Dam Safety Assessment of CCW Impoundments

**NRG REMA LLC – Shawville Generating Station
Shawville, Clearfield County, Pennsylvania**

**United States Environmental Protection Agency
Washington, DC**

December 16, 2013

FIGURE 3

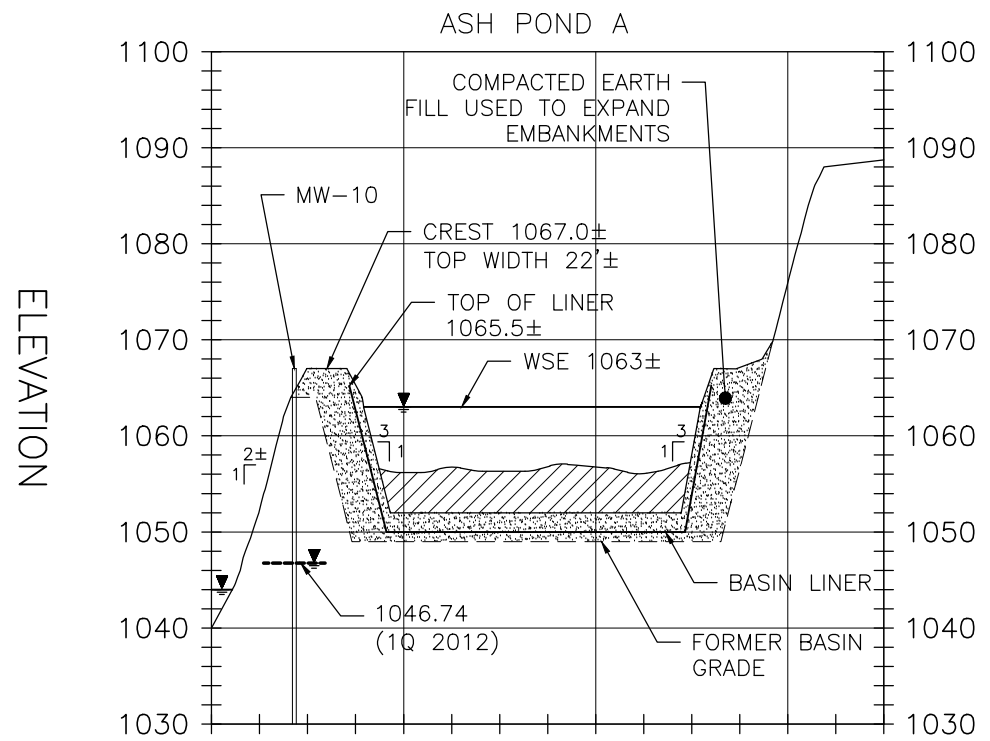
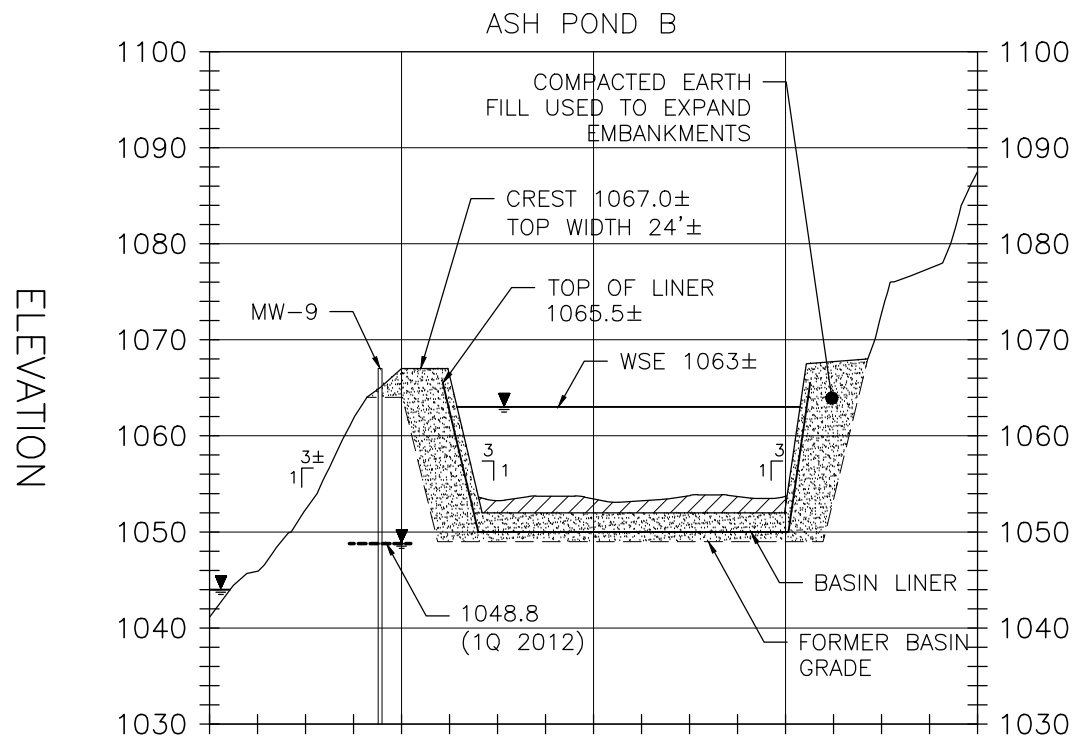
In the report, it is apparent that the existing units, Ash Pond A and Ash Pond B, are built on top of the decommissioned Pond 2. The report goes on to state that the northwest embankment of the ponds is primarily composed of the natural slope of the river bank with an additional approx. 2' diked portion overlaying the natural slope to provide drive access on the crest. It does not appear from the report that the natural slope is armored in any way by rip-rap or other material protection.

Does the configuration of the embankment, specifically as seen in elevation views from Figure 3 in the attachments of the report, present a concern in a flood condition in the West Branch of the Susquehanna River, i.e., elevated phreatic surface and potential subsequent downstream rapid drawdown condition in the downstream(outboard) slope? Additionally, would it be overly-conservative to analyze the downstream embankment based on its configuration and subsequent lack of lateral soil pressure buffering the embankment?

We have evaluated your questions regarding the lack of stability analysis of the northwestern slopes and offer the following clarifications/discussions:

5. The impoundment is planned for closure in about 2 years .

If this impoundment were to remain in operation for an extended period of time, we would likely recommend a geotechnical study and slope stability evaluation. However, given it's long history with no incident and upcoming closure in the near future, we believe a regular visual monitoring plan looking for signs of slope distress is the most practical recommendation for Ponds A and B.

Figure 2 – Cross Section 13-13 of the Northwest Berm of Ash Pond A

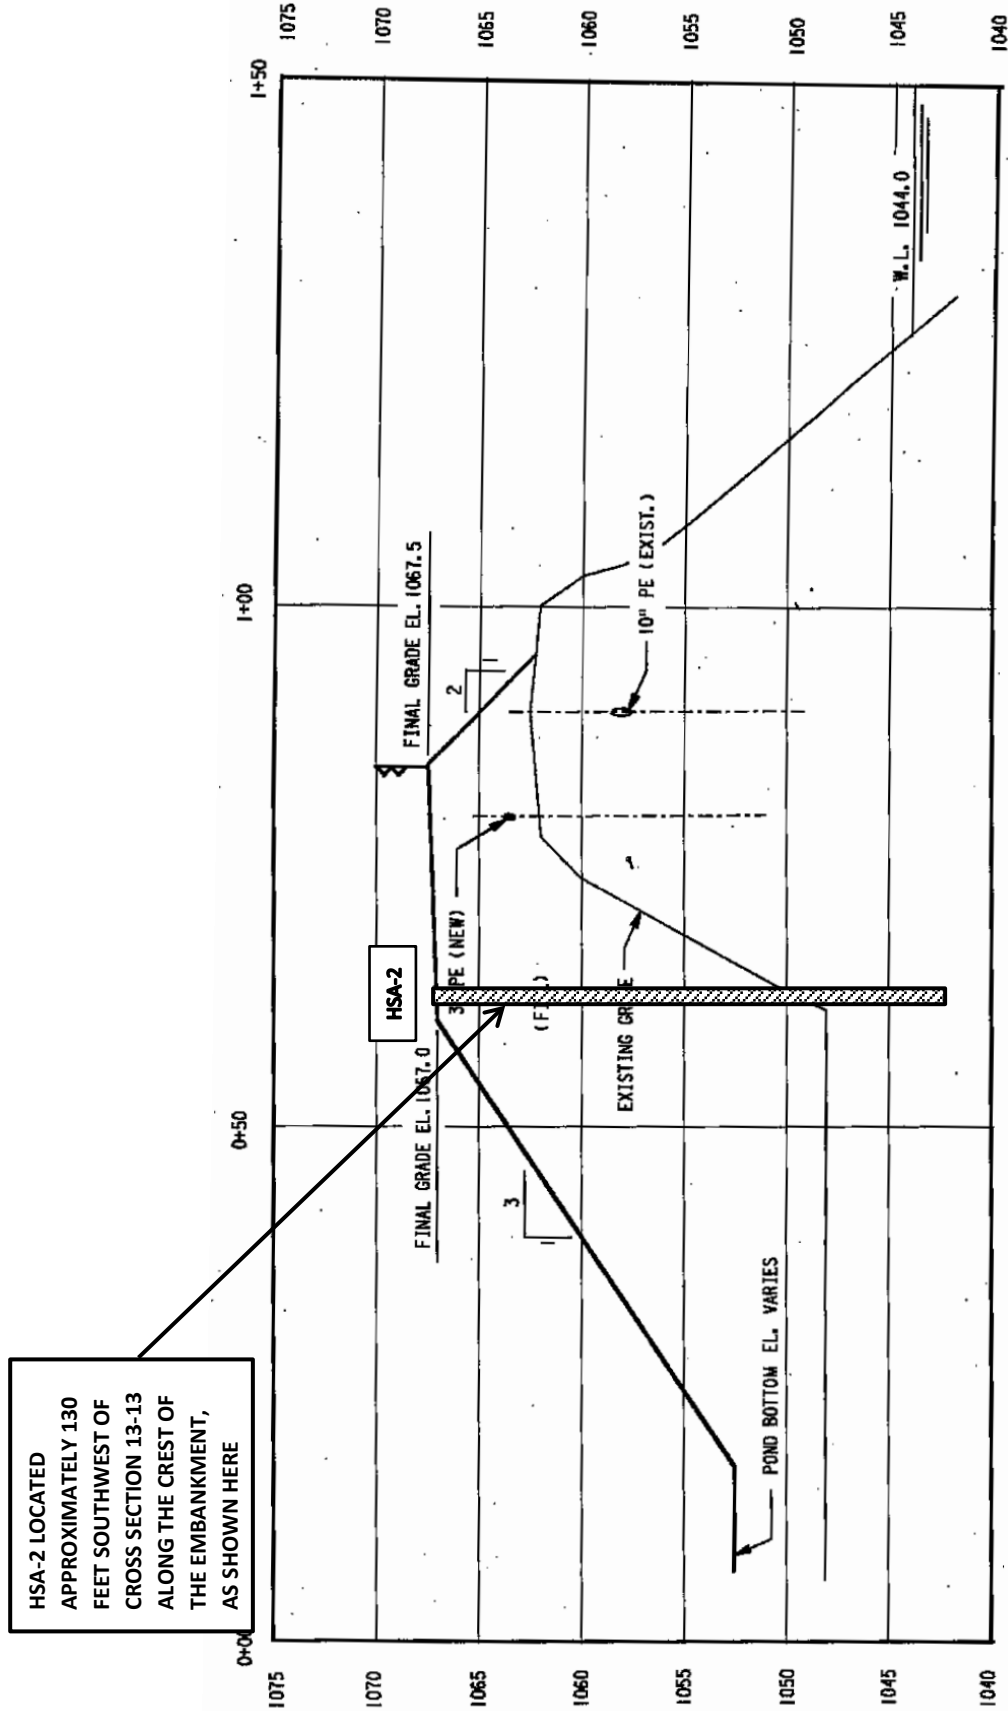
Geosyntec performed a stability analysis of the ponds' embankments. One representative cross section was selected for the analysis based on review of subsurface conditions, visual inspection, and pond geometry. The location of the selected cross section is the approximate center of the northwest embankment of Ash Pond A, as shown in Figure 1. This section was selected because of its proximity to HSA-2, where the weakest soil layer was encountered. In addition, Ash Pond A is the primary pond, meaning that water levels in Ash Pond A are typically higher than in Ash Pond B at any given time. Thus, the selected cross section at Ash Pond A represents the critical cross section and analysis results will likely represent the lowest expected factor of safety against failure of the BAPs' embankments.

The geometry of the embankment was obtained from the design plans prepared by Gilbert/Commonwealth, Inc., dated August 1987. Post-construction survey was not available to Geosyntec at the time of this evaluation. As a result, the actual steepness of the existing slopes could not be confirmed.

Based on the assessment described in this letter, Geosyntec recommends that the Condition Assessment result is “Satisfactory”. Other than a ground-run survey to verify the dimensions (i.e., slope) of the embankments, no other action is recommended at this time.
